AGENDA TOWN OF PITTSFORD PLANNING BOARD JANUARY 27, 2025

Response to Town of Pittsford DRC Review Comments Re:

Warfle Subdivision

74 East Park Road, Town of Pittsford, NY

SANITARY LATERAL TRENCH
NOT TO SCALE

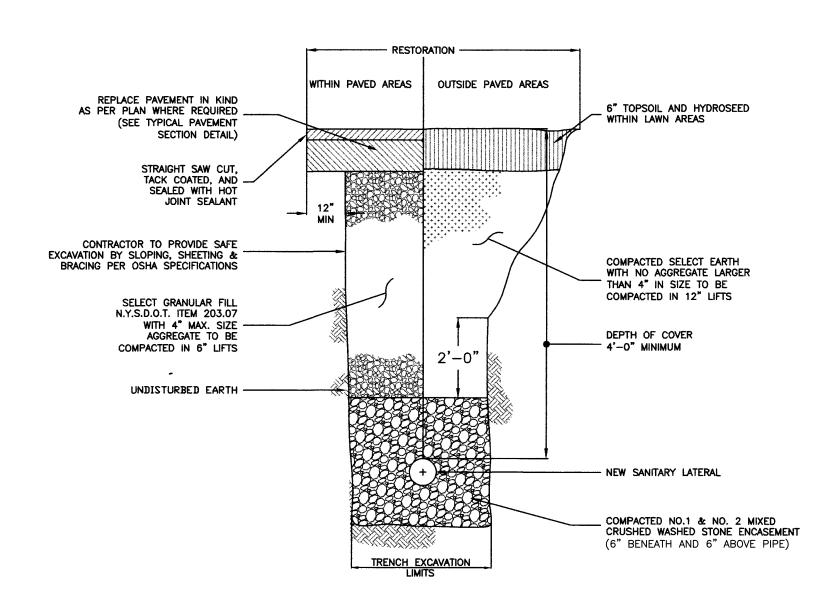
10. Please provide an estimated lateral invert elevation at the proposed connection to the sanitary sewer main. (TRE)

11. At the proposed sanitary sewer lateral, please add a note that states, "Prior to starting the proposed lateral connection to the Town sewer main, the Pittsford Department of Public Works/Sewer Department shall be contacted to inspect the connection." (DPW)

The estimated sewer lateral invert elevation has been added to the Site Plan, Dwg. S-1.

The required note has been added to the Site Plan, Dwg. S-1.
